Three Mile Island Nuclear Station, Unit I (TMI-1)  
Operating License No. DPR-50  
Docket No. 50-289  
Asymmetric LOCA Loads (ALL)

Subject: GPU Nuclear Corporation (TMI-1)  
Master Services Contract, Effective date: June 1, 1977  
Reference Nos.: B&W 582-7105, GPU M77120  
Task 202 - Analysis of Hot Leg Support for Asymmetric LOCA Loads

CALCULATION DATA/TRANSMITTAL SHEETDOCUMENT IDENTIFIERCALC. 32 - 1135359 - 00TRANS. 86 -                      -                     TYPE:        RESEARCH & DEVELOPMENT        SAFETY ANALYSIS REPORT        NUC. SERV. INPUT        DESIGN RQMT.        DESIGN VERIF.        OTHERTITLE Review of GPUN Calculation For TMI Restraint Bracket DesignPREPARED BY C. C. Lin

To review GPUN design calculation for TMI Hot Leg Restraint Bracket

FIG. 1

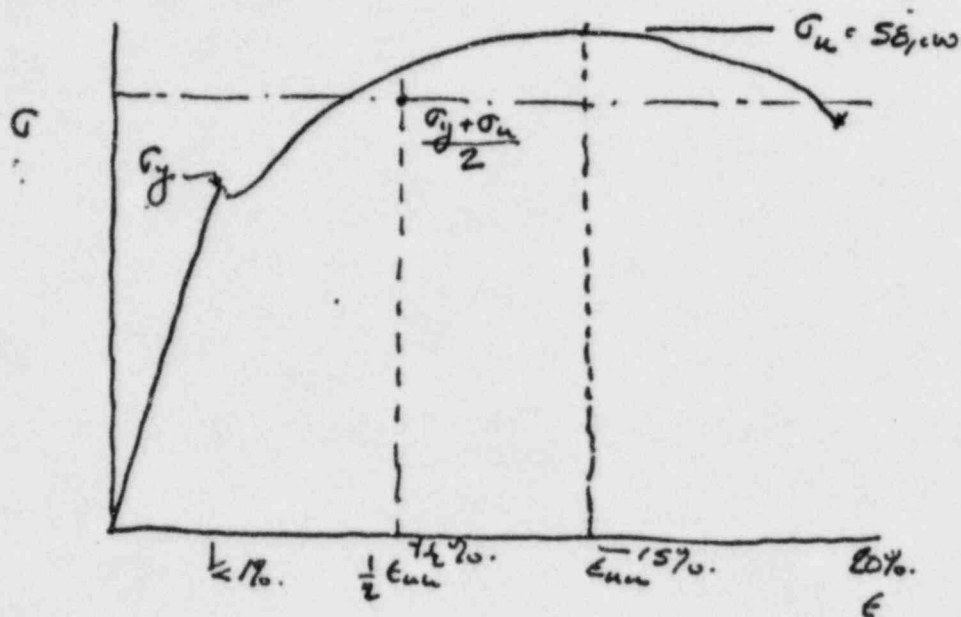
1. USING NRC SRP 3.6.2, THE MAX. STRAIN FOR RESTRAINTS SHOULD NOT EXCEED ONE-HALF THE UNIFORM ULTIMATE STRAIN,  $\frac{1}{2} \epsilon_{uN}$ . THE STRESS ASSOCIATED WITH THIS STRAIN IS  $S_u = 51.15 \text{ KSI. (FIG. 1)}$

$$\sigma_t < S_u.$$

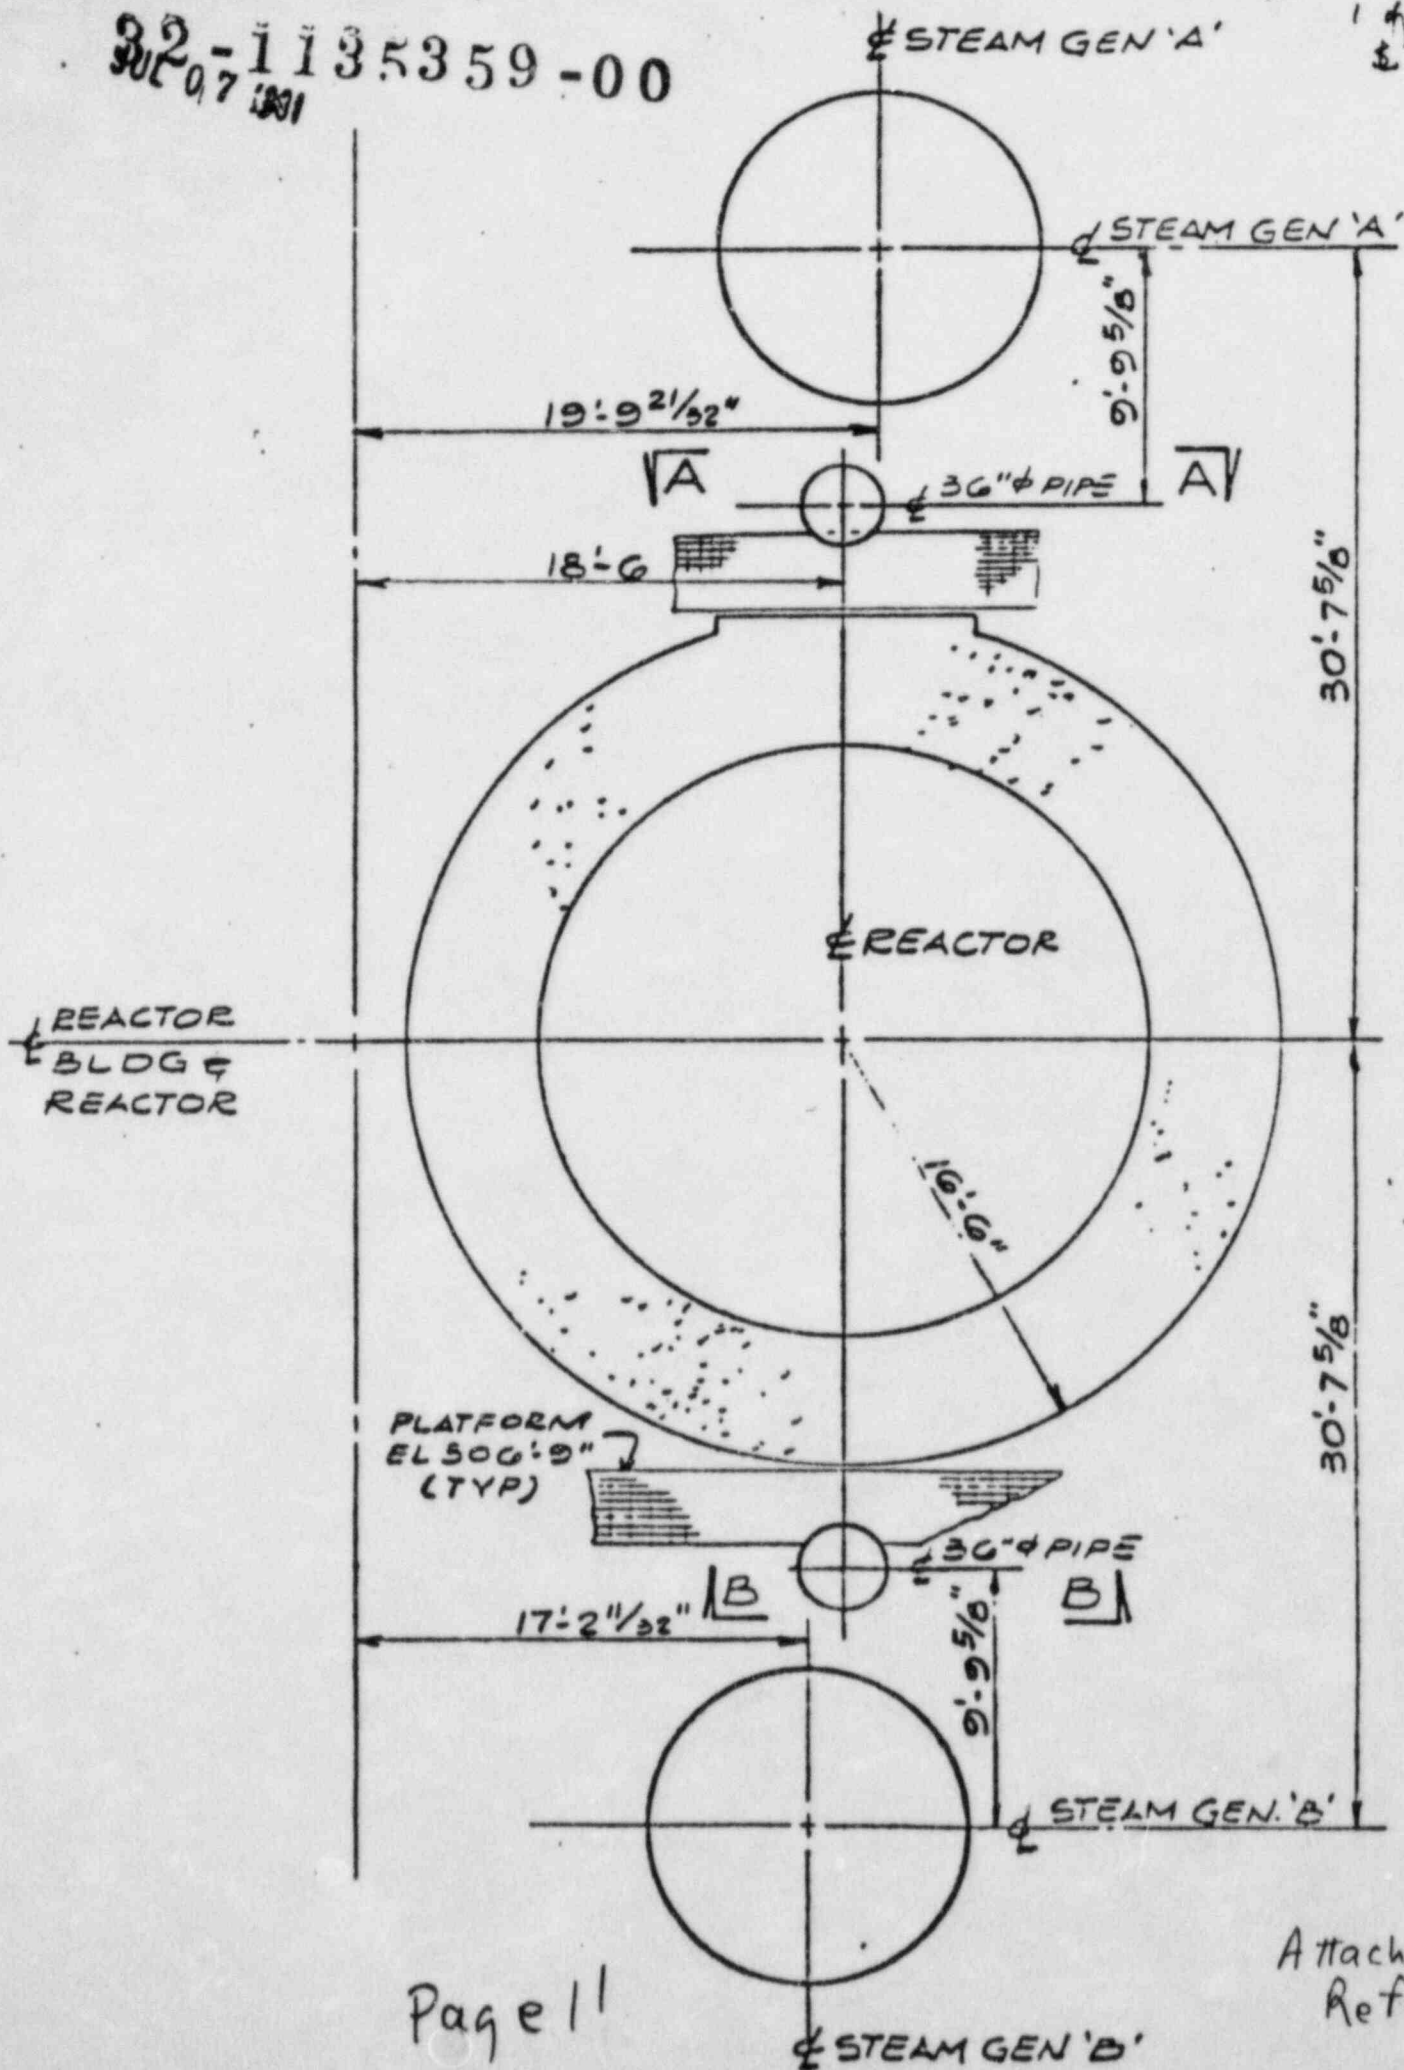
$$F = (2t) \left( L - \frac{d}{2} \right) (0.7 G_u^P) \quad \text{EQ. 5.35 IN FISHER & STRUICK.}$$

$$F = (1.4) \left( 7 - \frac{4.03125}{2} \right) (3) (60.9)$$

$$F = 1274.9 \text{ KIPS.}$$

$$F > F_{\text{APPLIED}} ; F_{\text{APPLIED}} = 1271.7 \text{ KIPS.}$$

THE LIMITING LOAD CAPACITY IS GREATER THAN THE APPLIED LOAD
